Re: Food Lion - Rockwall, Final Plat

## FOOD LION SITE PLAN - FM 740/FM 3097 AREA

Re: Response to Final Plat Review

FOOD LION - ROCKWALL  
AN ADDITION TO  
THE CITY OF  
ROCKWALL, ROCKWALL CO.,  
TEXAS  
E. TEAL SURVEY, ABST. NO. 207  
SEPTEMBER, 1990

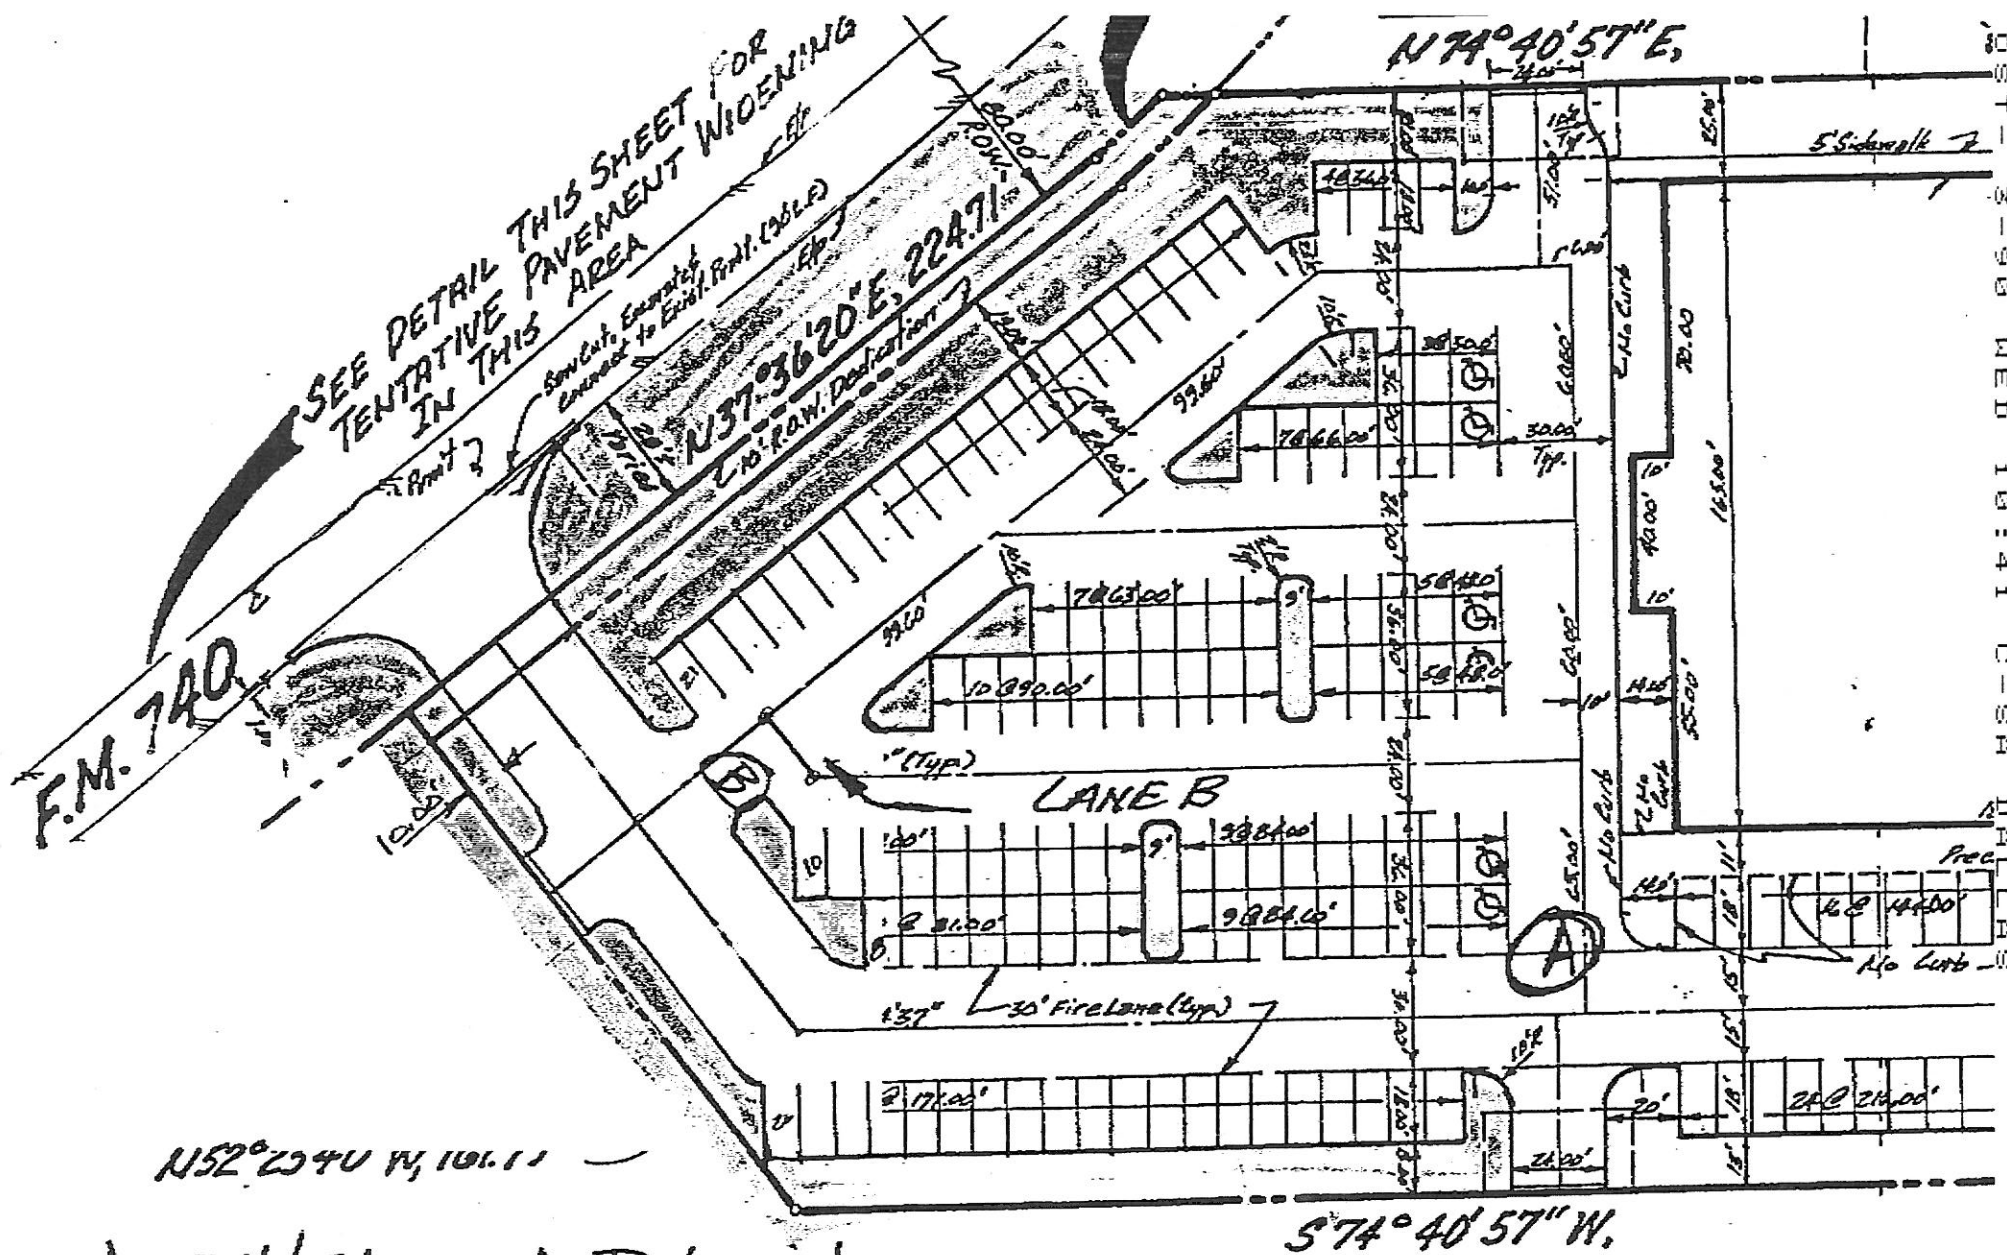
1. Correct the name of the plat
2. Correct the ROW dedications on both FM-740 and FM-3097
3. Identify the point of beginning
4. Add Lot 1, Block A to the plat
5. Please provide documentation that the easements for access conform to the site plan. They don't appear to do so on this draft.
6. Add "Recommended for Approval" above the Planning and Zoning Chairman's signature.

We are in concurrence with your Six Point Final Plat Revision Recommendation. All six comments will be addressed appropriately.

Design based upon  
• 40 mph design speed  
• widening on both sides  
of existing centerline.

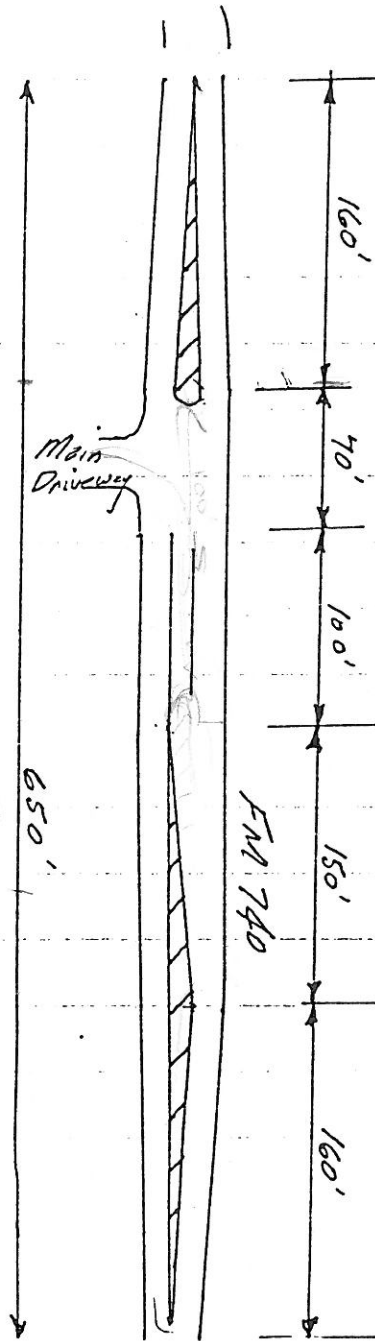
3. The design for FM 740 as proposed by the developer, is inadequate. The transitions are too abrupt for a design speed of 40 mph, the storage length is too short, and the median opening is also inadequate. The design shown accomplishes all of the widening along the west side of FM 740 - this is not recommended because it requires longer transitions.

4. The recommended left turn lane design is shown on the attached sketch. It widens the roadway by 12 FT, centered about the centerline of the existing road. If all of the widening must occur along one side, the transition lengths become 320 FT each, instead of 160 FT. It should be pointed out that incorporation of this design will begin the transition north of the Mr. M driveway. Because of this, the transition in this area may have to be lengthened more to provide adequate guidance to southbound motorists.

RIDGE ROAD (F.M. RD. 740)

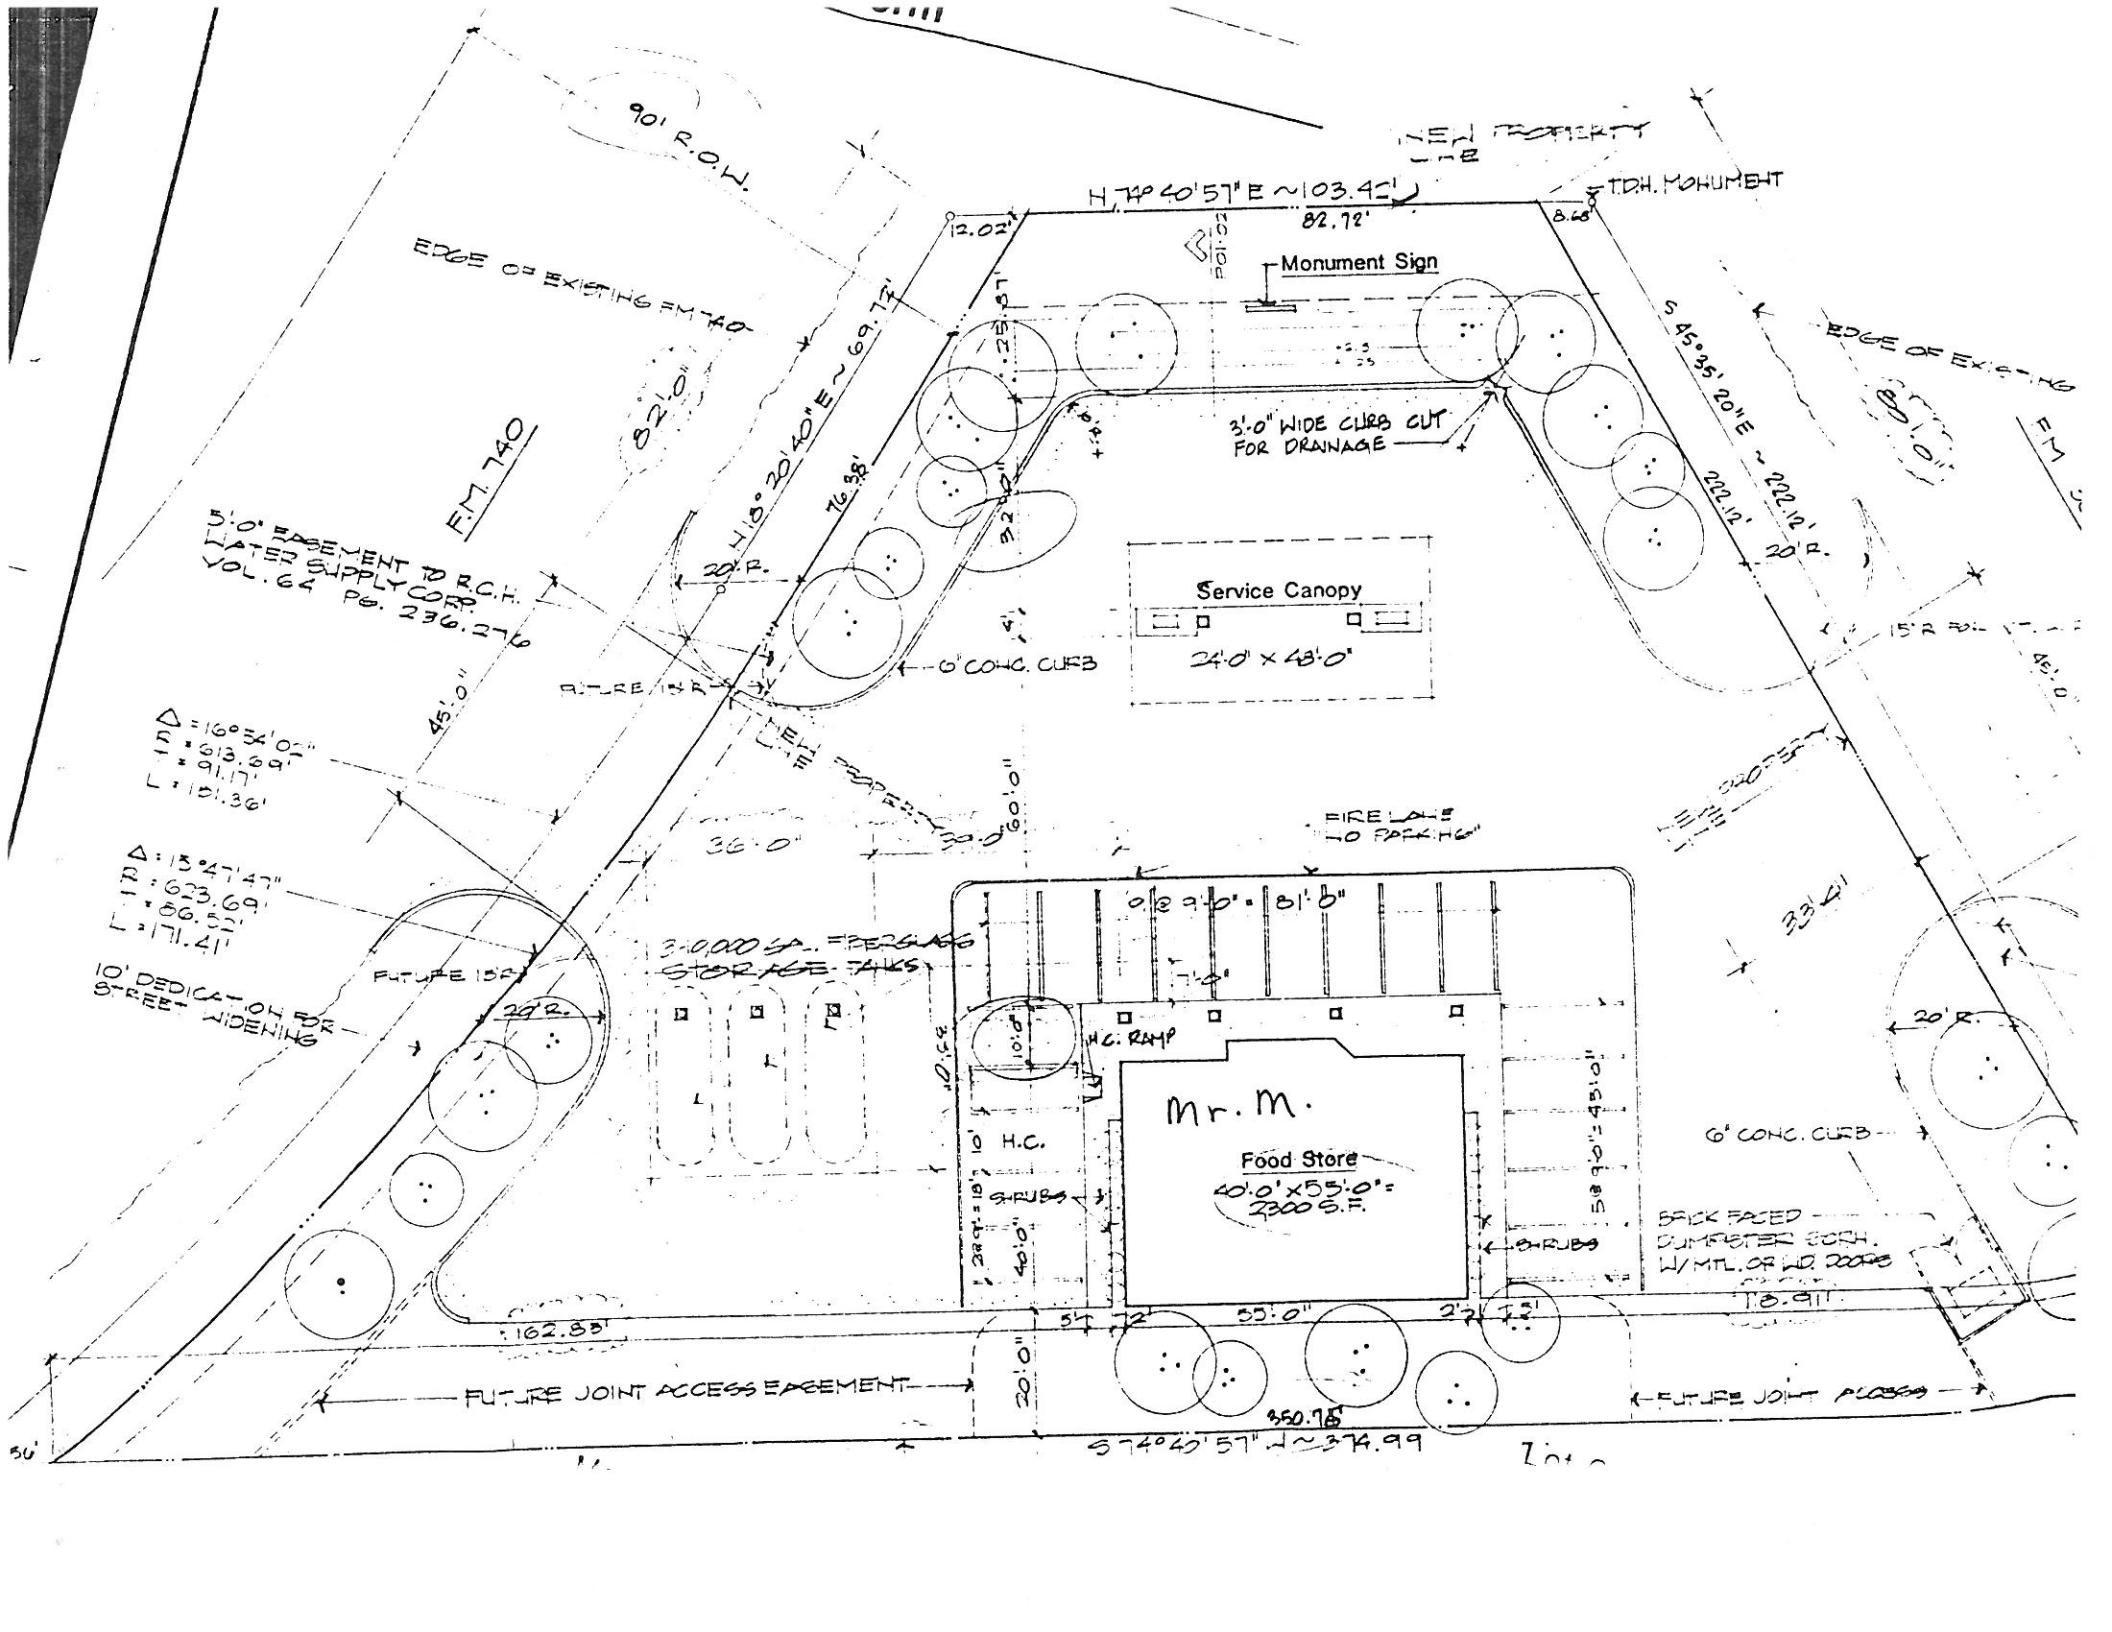
In regard to the turn lane on FM-740, as we discussed on the phone, we will want to look at providing some spacing in the striping for the Mr. M store to the north and the cleaners being constructed just south of your site. Attached you will find a copy of the site plan for the Mr. M site and the cleaners so that you can identify their driveway locations on your turn lane drawing. A width of approximately 40 feet should be used for the striping spacing. I have also attached a rough sketch of this concept.
